**DECLARATION OF BRADLEY J.
HERREMA IN SUPPORT OF MOTION
FOR COURT TO RECEIVE AND FILE
THE 2024/2025 ANNUAL REPORT FOR
THE GROUND-LEVEL MONITORING
PROGRAM**

Appendix A: Recommended Scope of Work and Budget of the Ground-Level Monitoring Committee for Fiscal Year 2025/26
Appendix B: Response to GLMC Comments

2024/25 Annual Report for the GLMP

Figure 3-9b
Vertical Ground Motion across
Northwest MZ-1: 2017-2025

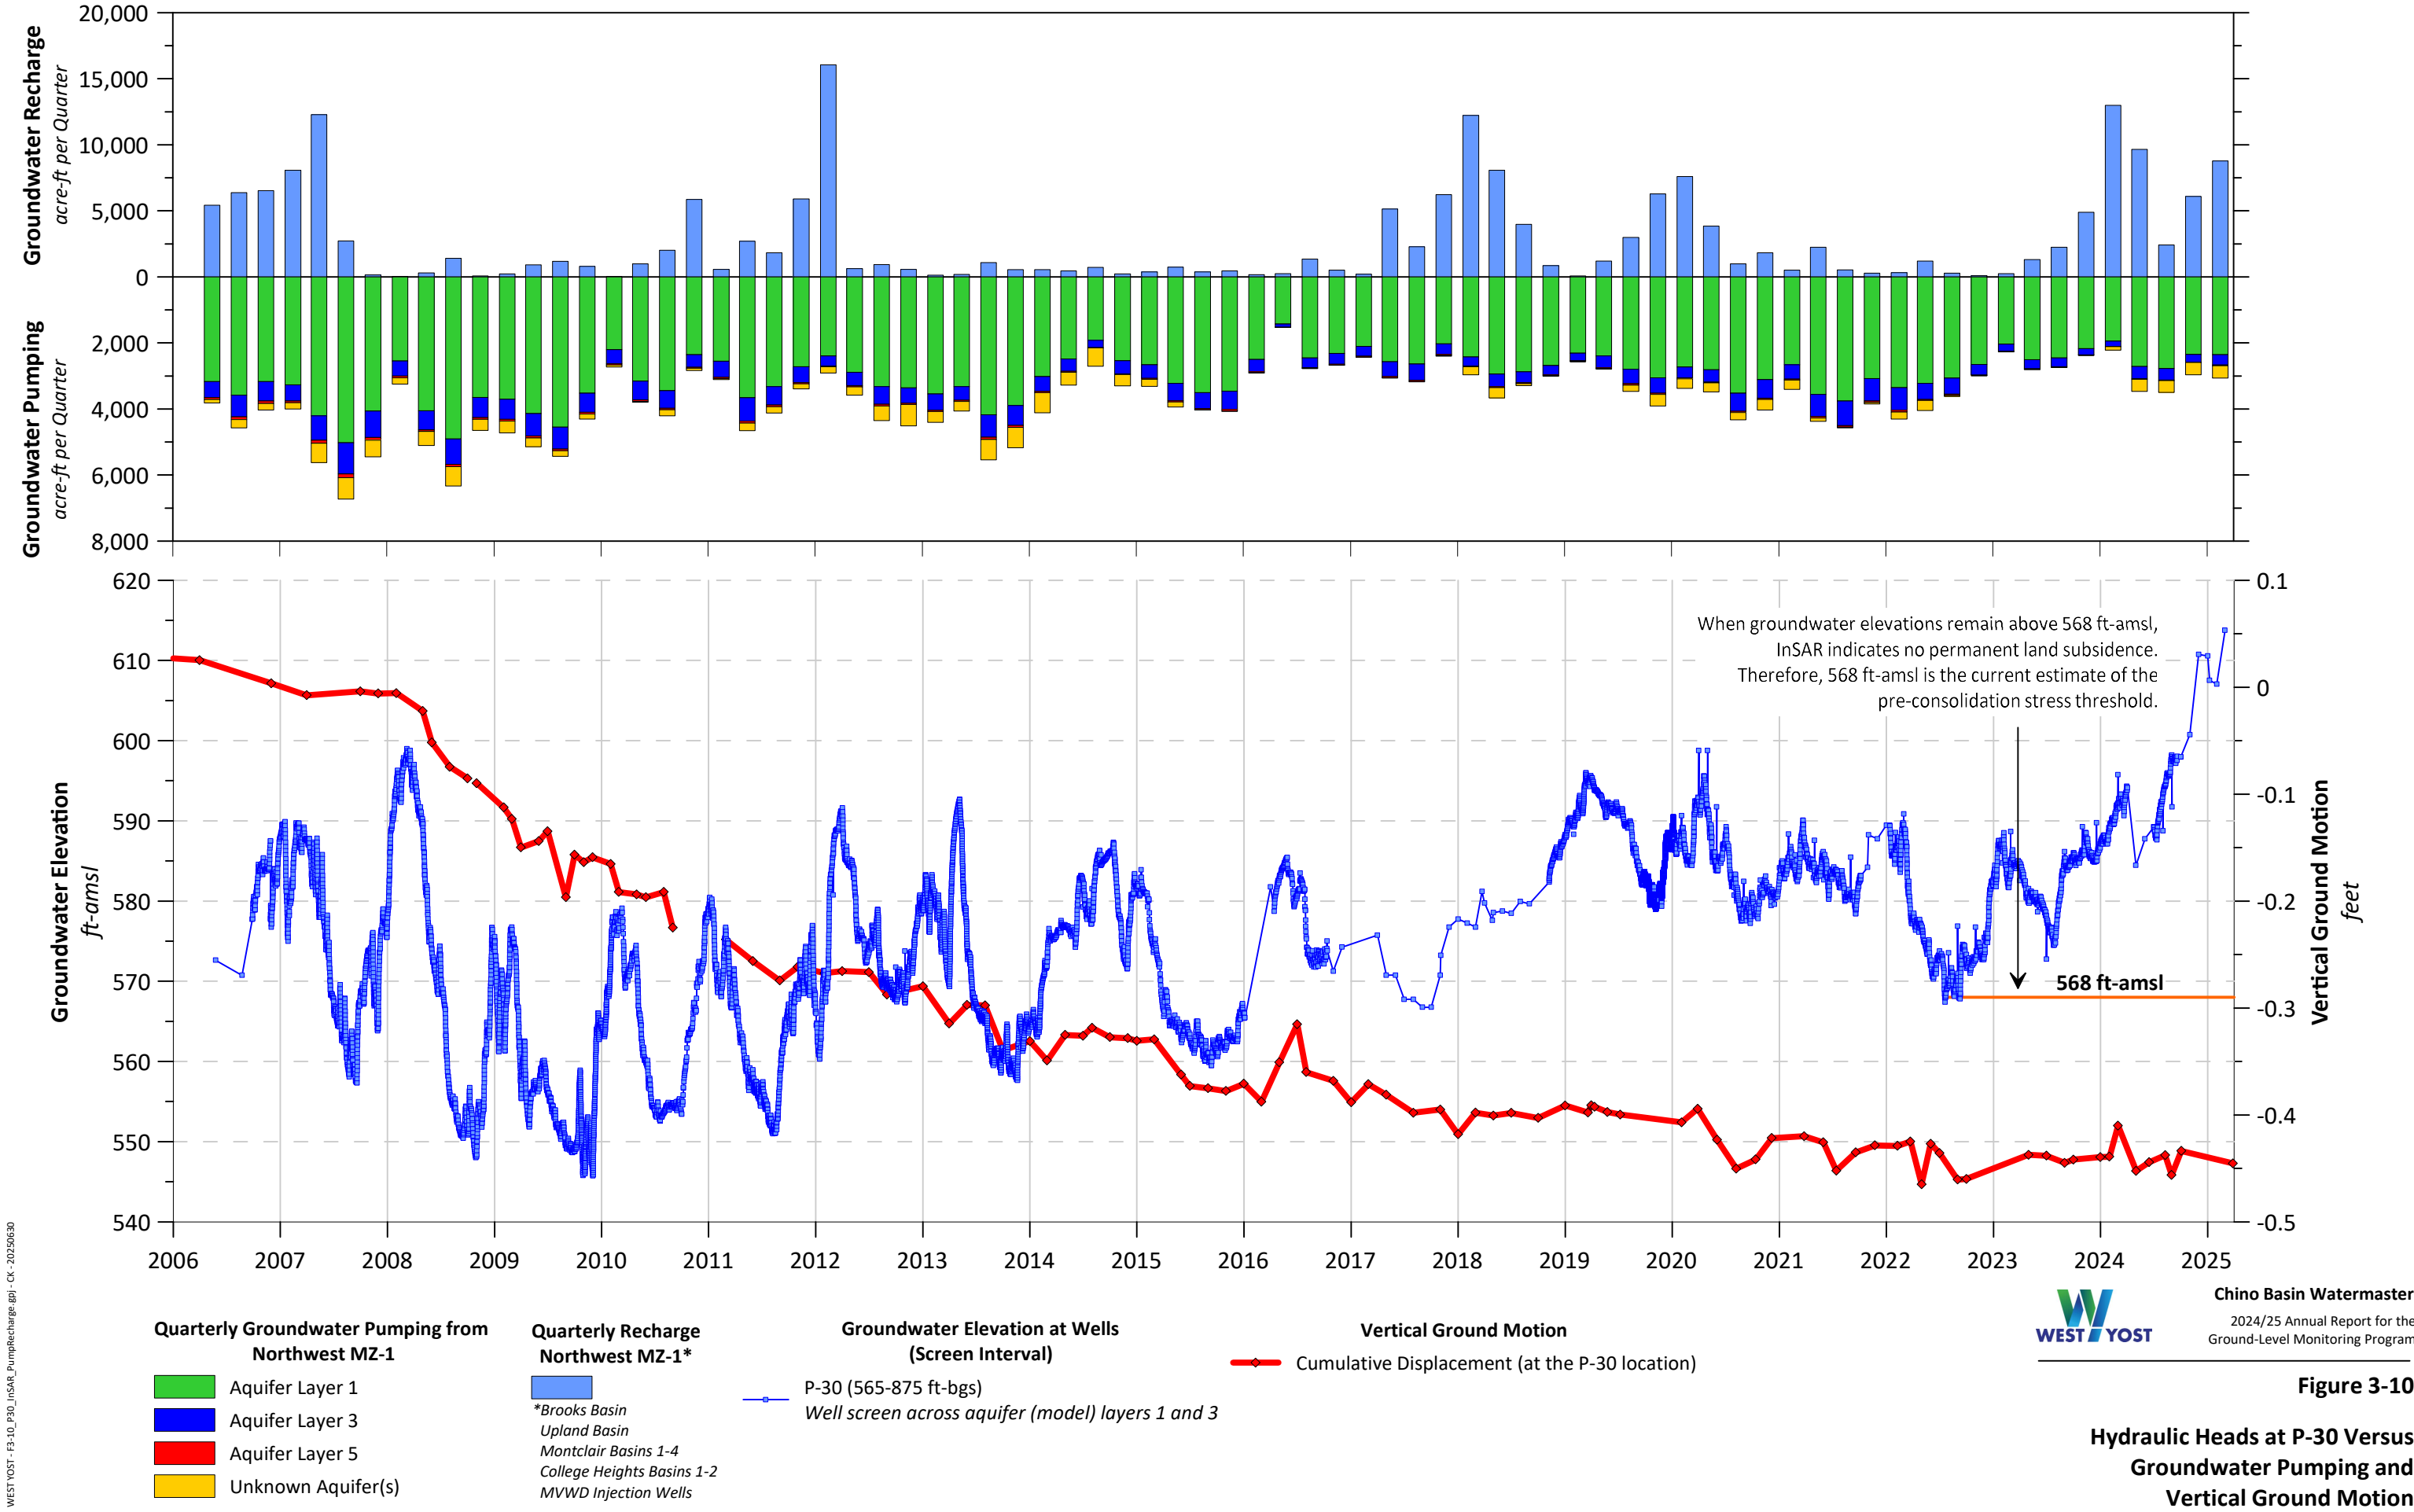
Comment 9 – Figure 3-9b: Vertical Ground Motion across Northwest MZ-1: 2017-2025

Benchmark data do not show differential subsidence across the San Jose Fault for the 2017 to 2025 period. Benchmark data are generally 2 or 3 times lower in magnitude than the InSAR data in Northwest MZ-1 near the PX. Please discuss in more detail in the discussion of Figure 3-9b.

Inspection of the map on Figure 3-9b show that while the magnitudes of ground motion may differ slightly between the monitoring techniques, both datasets show a similar spatial pattern of differential land subsidence across the San Jose Fault. On the northwest side of the fault, both the InSAR contours and benchmark data indicate uplift, whereas on the southeast side, both show subsidence, with the greatest downward motion occurring near the PX facility.

Figure 1

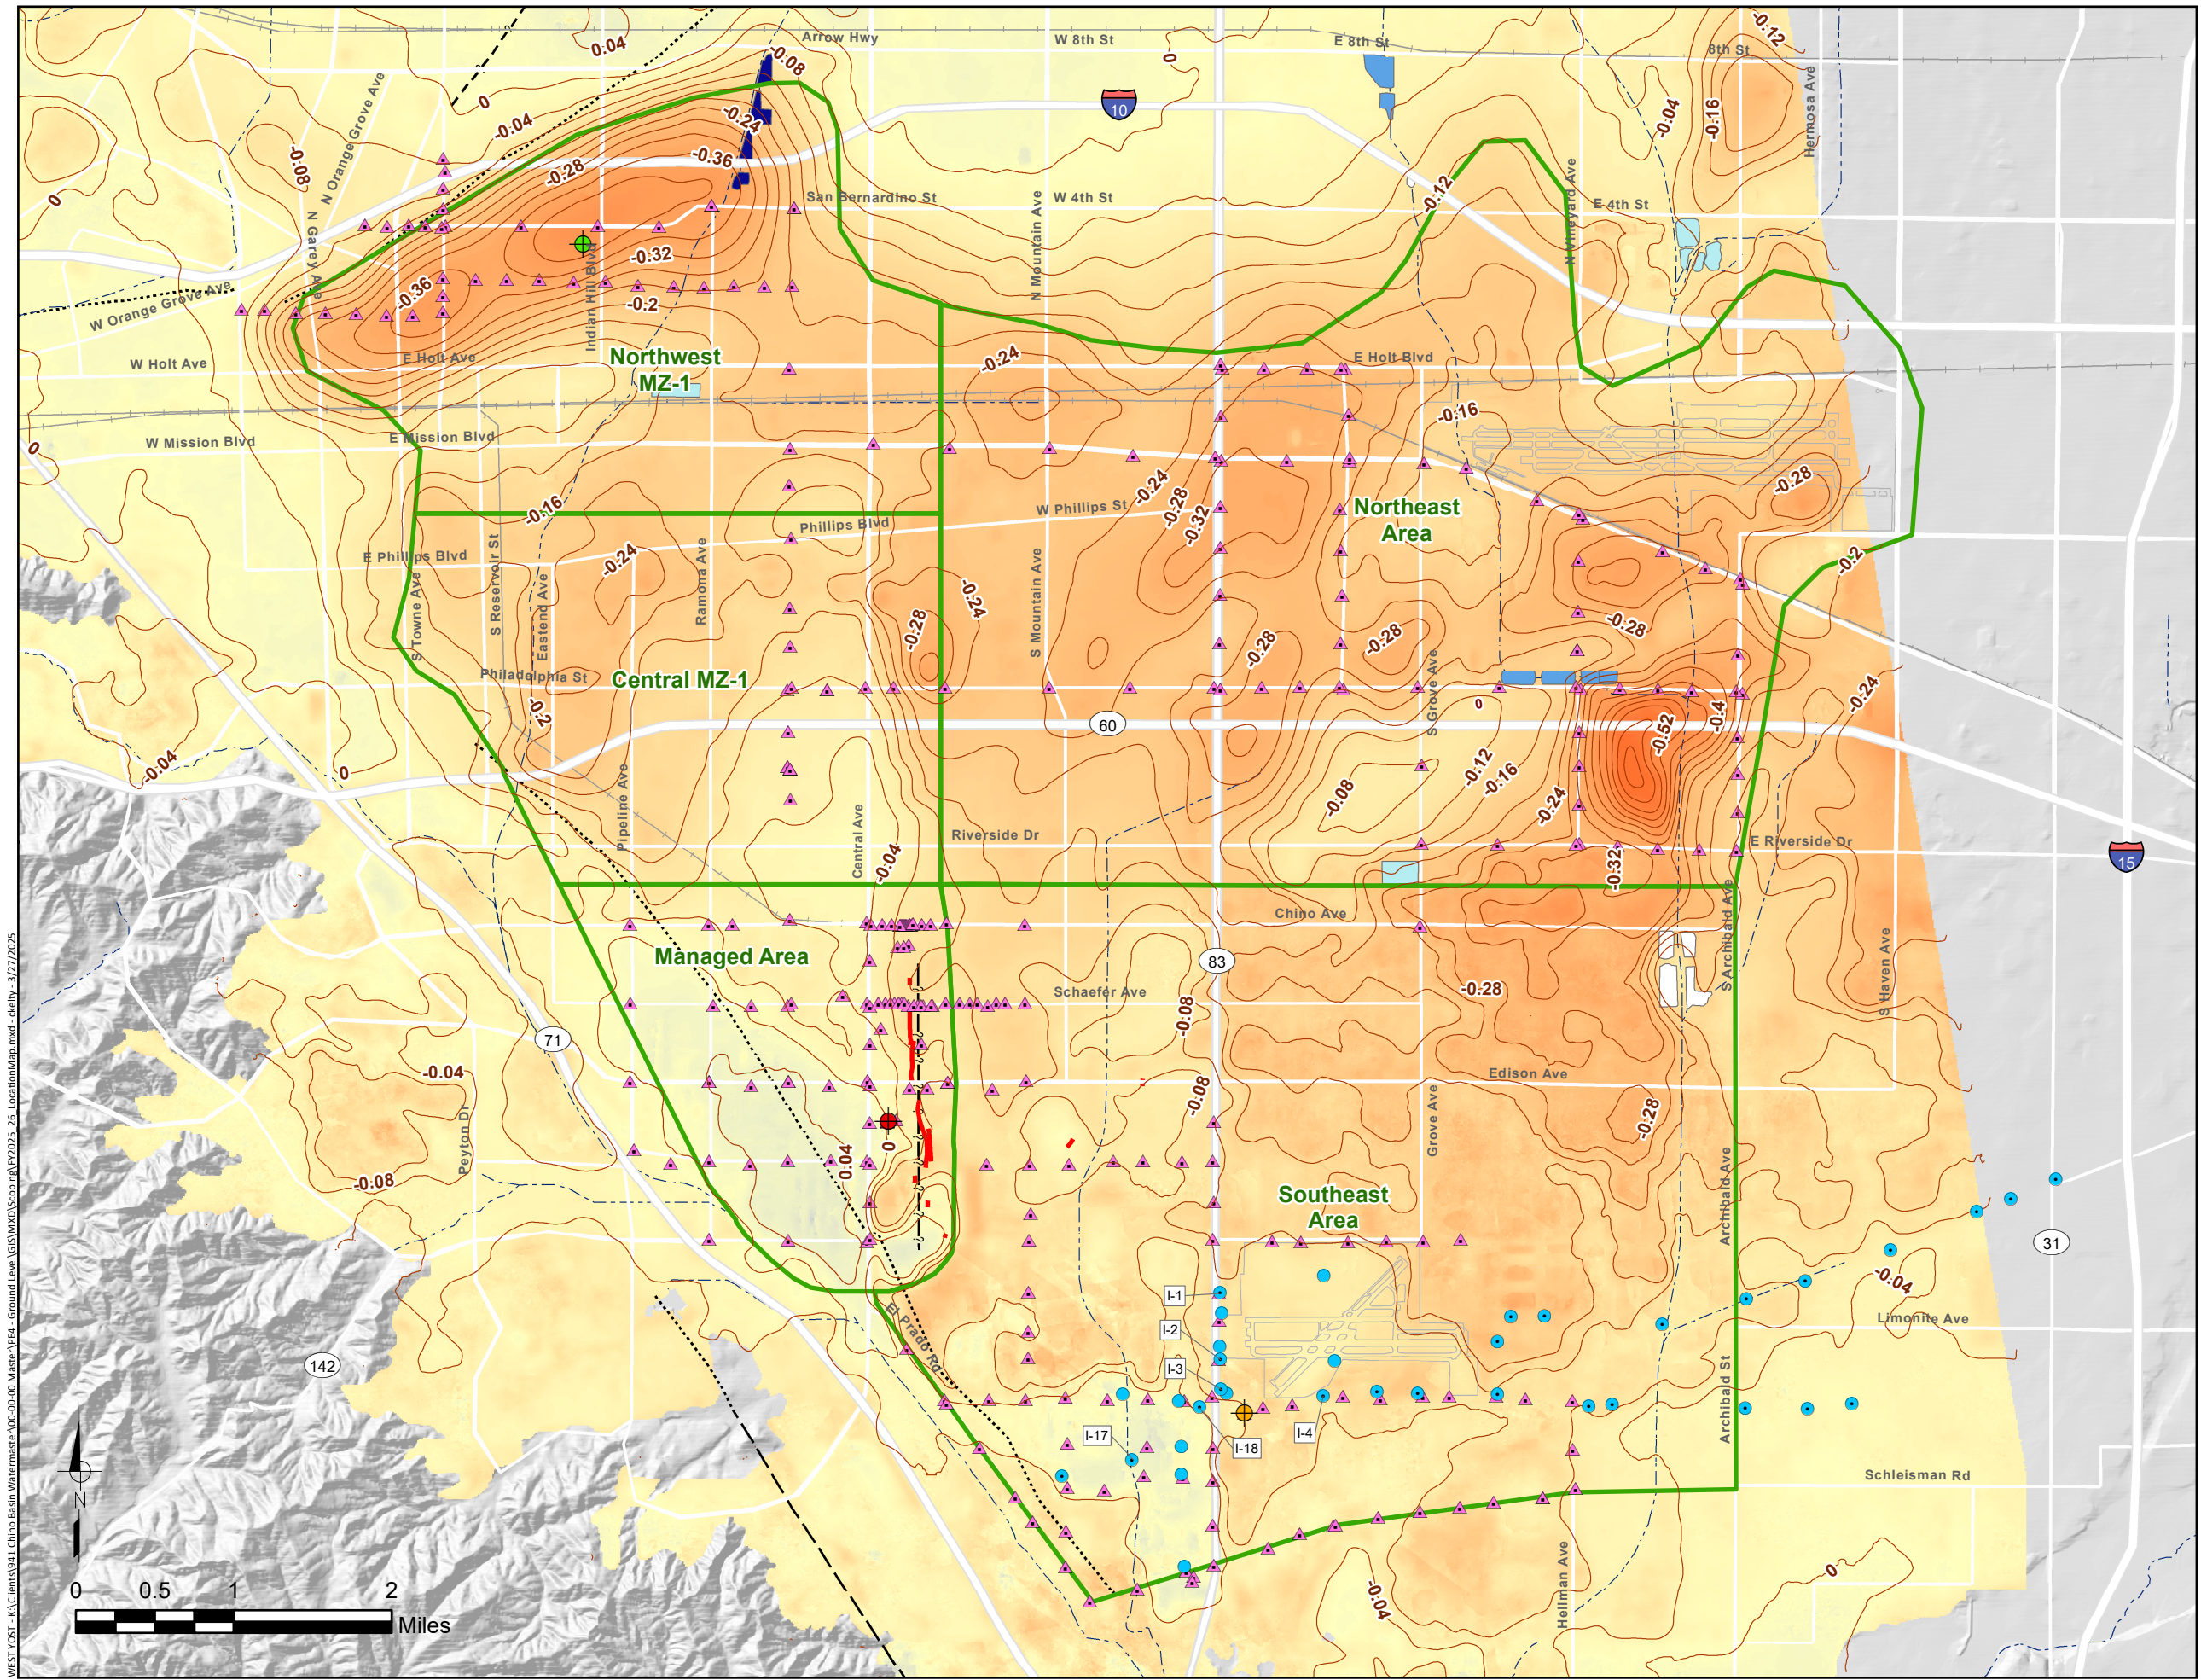
Comment 1 – Figure 1 Ground-Level Monitoring Program Fiscal Year 2025/26.

The major street to the west of the historical ground fissures in Figure 1 is Central Avenue. The figure has been updated to include a label for Central Avenue.
